Fisher Information Notice: FIN 2019-01

Subject: Mechanical Setting of Disk/Stem Taper Pins

Equipment Affected by this Fisher Information Notice:

Figure 1: Proper Staking - Pin surface is slightly below disk surface and disk material is staked over the top of the pins

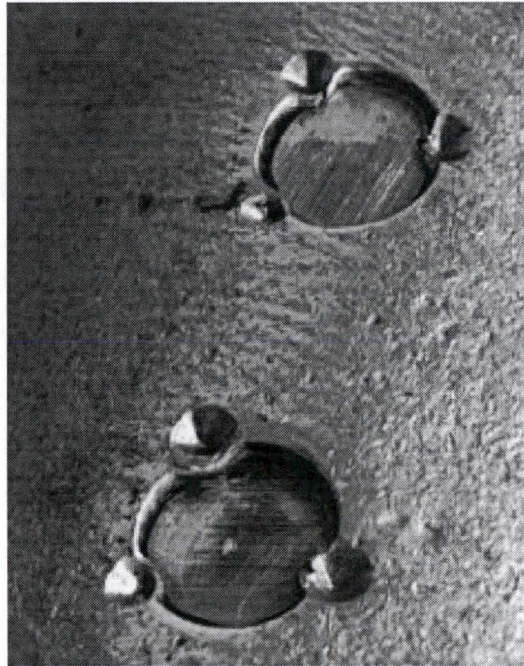
A review of the assembly showed that the pins had been ground flush with the surface of the disk and then staked in three places. However, in order to properly secure the pins in place, the

surface of the pins must be below the surface of the disk prior to final staking and the disk material must then be deformed to roll over the edge of the pins. Previous guidance did not adequately describe the need to deform the material over the pin heads. As a result, Fisher has reviewed and revised the instruction procedure for clarity. The revised instruction on Mechanical Setting of Disk/Stem Taper Pins can be found below. Additionally, the below image shows one example of proper Taper Pin staking.

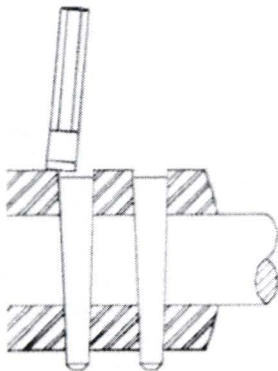
Fisher recommends the owners for these valve assemblies perform normal maintenance at regular intervals in order to inspect the valve assembly and replace worn, aged, and damaged parts. At the same time, the customer should verify that the taper pins are correctly installed and

reset them if necessary. Additionally, the customer should review their internal taper pin staking procedures to make sure they are in agreement with the below method or are appropriate for the specific application.

1. Install the disk and shaft into the valve body.
2. Insert the pins into the larger end of the pin holes. Without driving the pins in with a hammer, mark the match-line between the pins and the disk on the surface of the pins.

3. Remove the pins and grind the top of the pins down to the marked match-line
4. Reinsert the pins into the larger end of the pin holes. Drive with a hammer to seat the pins. The surface of the pin should be approximately 1/8" below the surface of the disk. Additionally, the smaller end of the pins should extend past the surface of the disk on the smaller end of the pin holes.

5. To stake the pins, deform the metal at the outer perimeter of the pinholes in three locations to secure the pins inside the disk. Ensure that disk material has been deposited over the pins in order to prevent them from slipping out. Additionally, ensure that the disk material is deformed deep enough to contact the top surface of the pins.

Stake the pins by deforming disk material in three locations from the circumference of each pinhole over the pins

Grind large and small ends of pins flush with surface of disc. Cover pins with seals that are the same material as the disc. Weld seals to disc.
